Town of Arlington, MA Redevelopment Board

Agenda & Meeting Notice November 7, 2022

3. Public Hearing Docket #3717 80 Broadway

Public Hearing Docket #3722 141 Massachusetts Avenue

② FALL 12PM

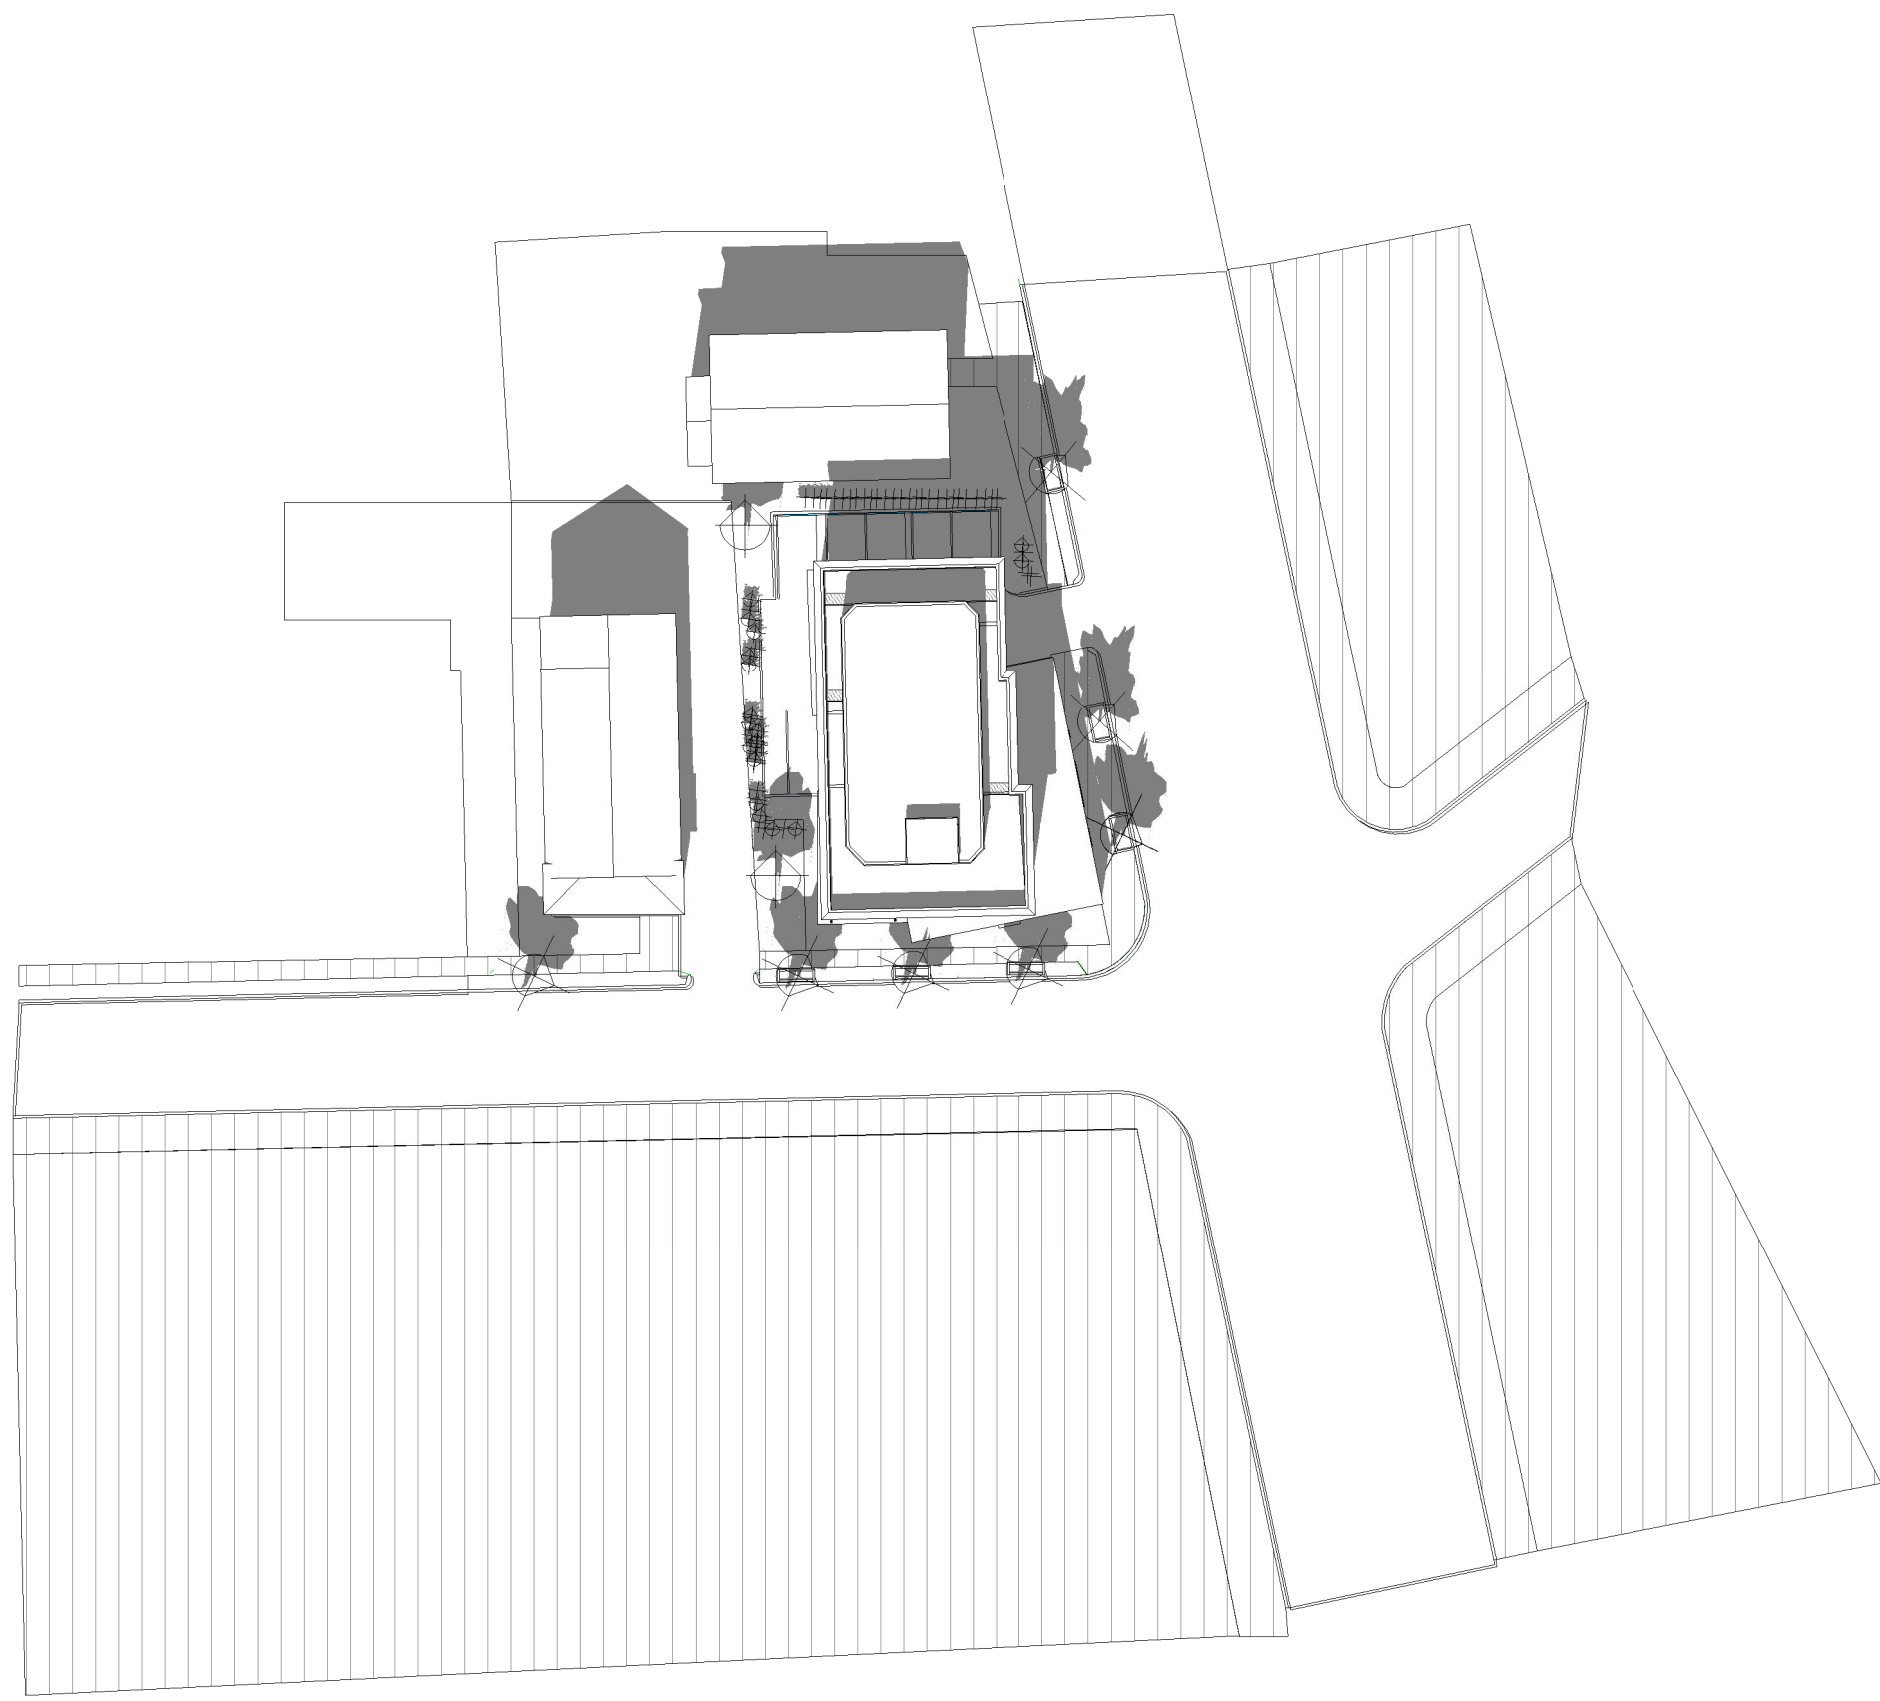
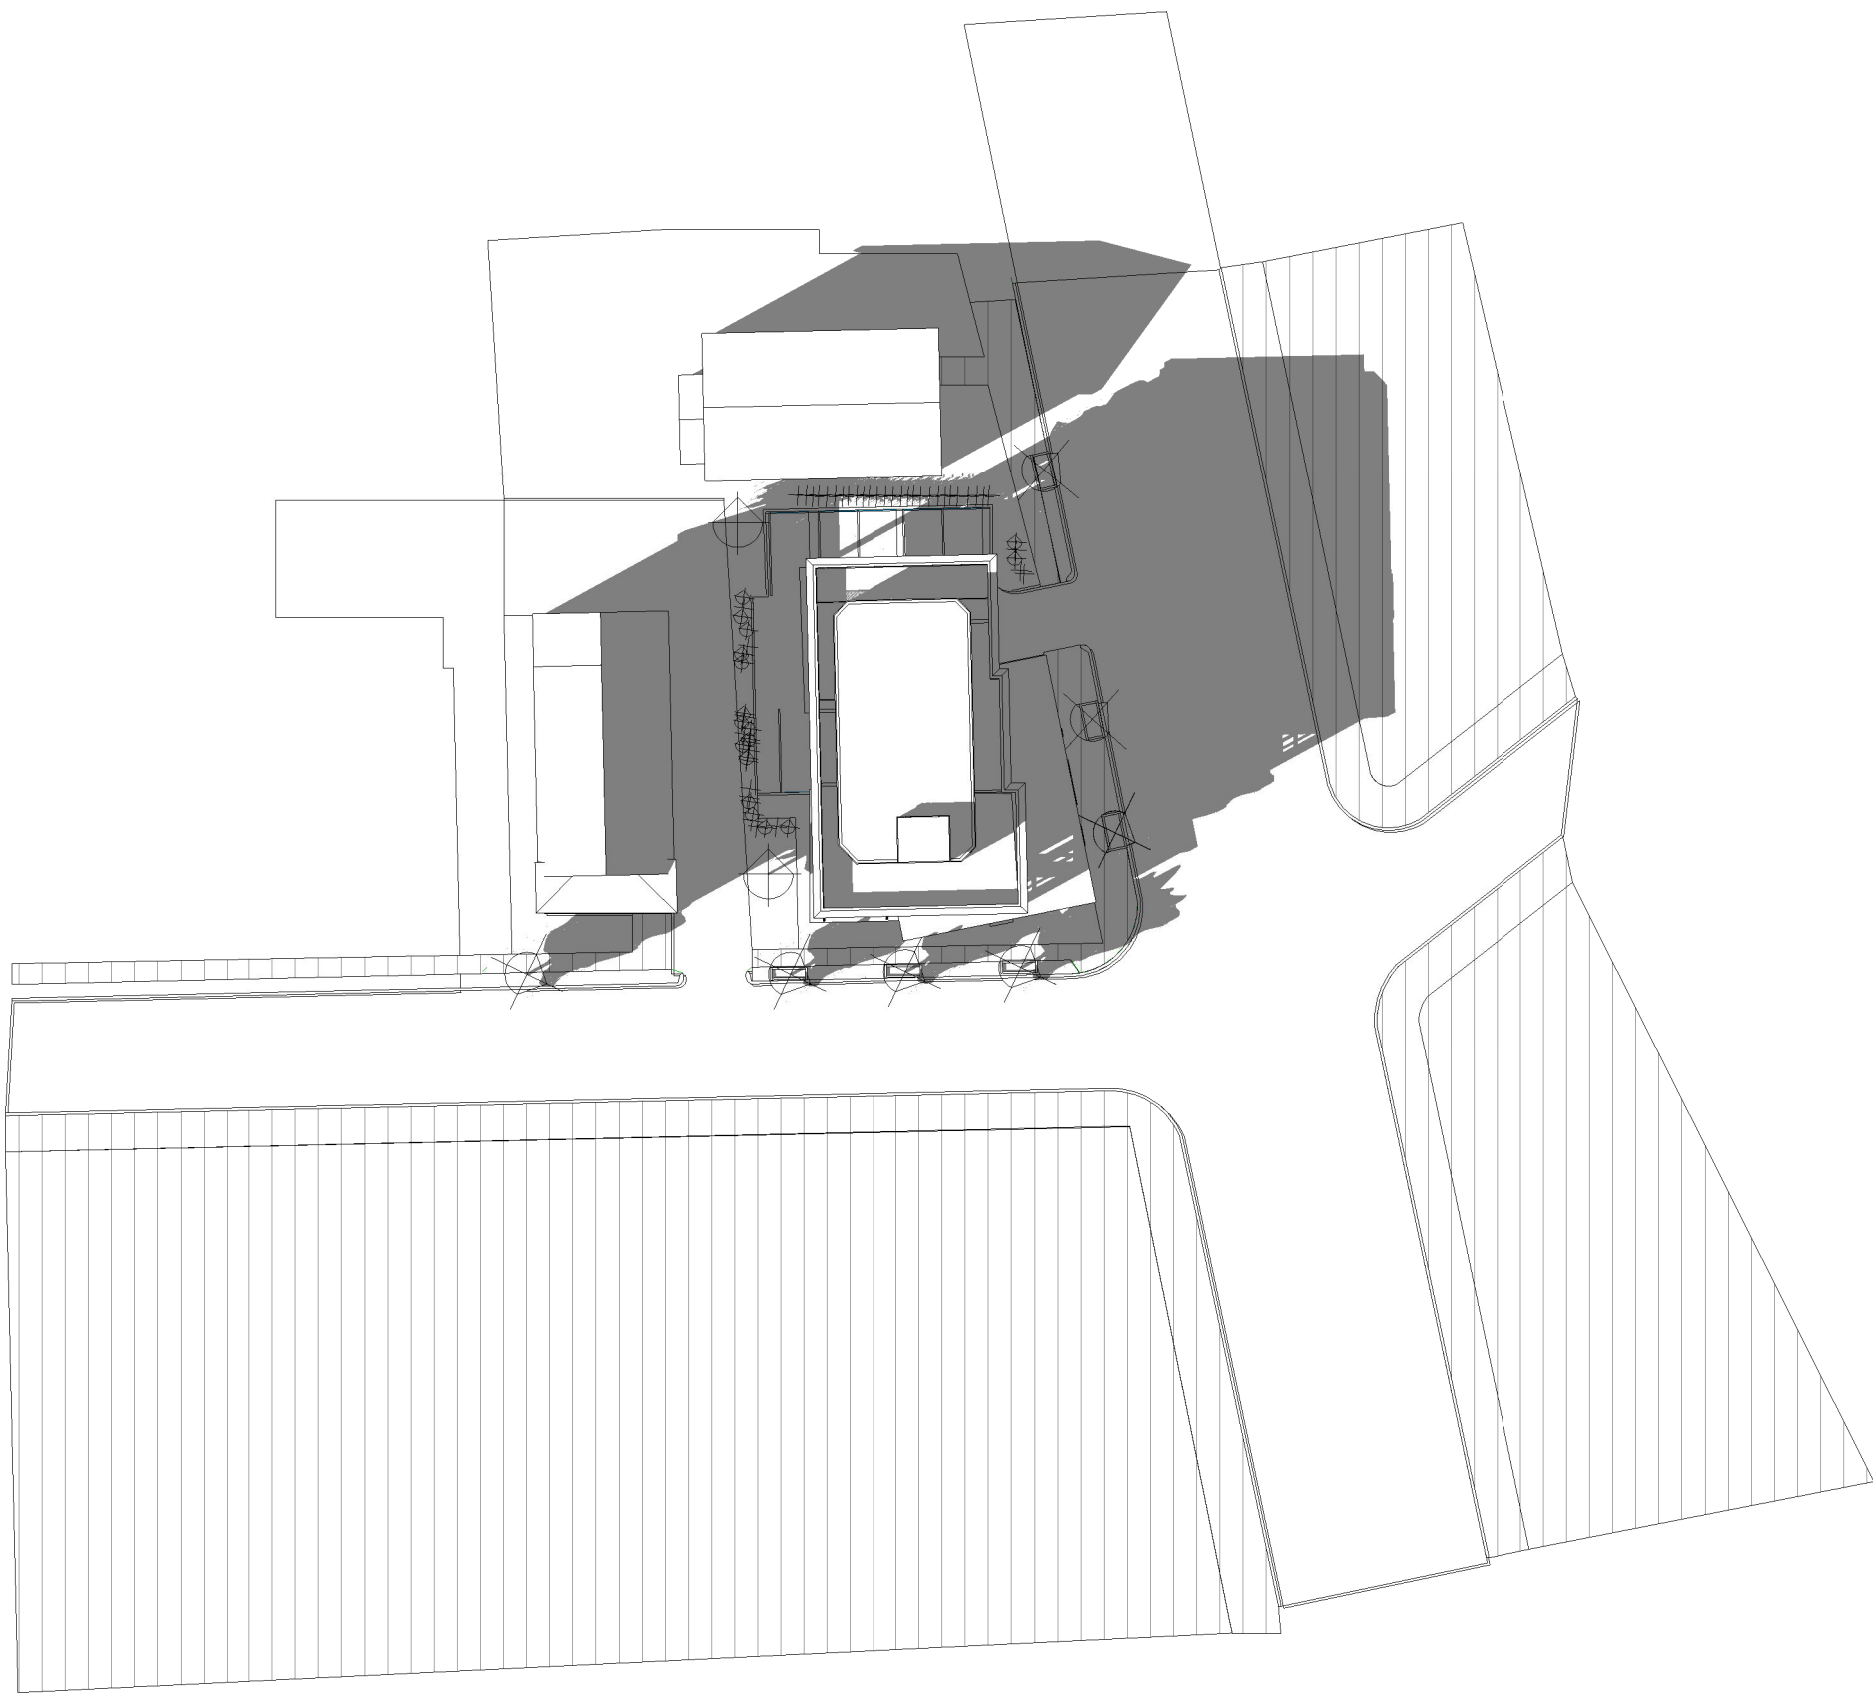
5. Could the applicant provide the Board with corrected and more detailed solar impact drawings A2.10 - A2.13? These drawings incorrectly show Broadway as running North to South, more than 60° off from reality. These drawings omit any detail of the affected properties, notably the array of solar panels on the roof of 88 Broadway.
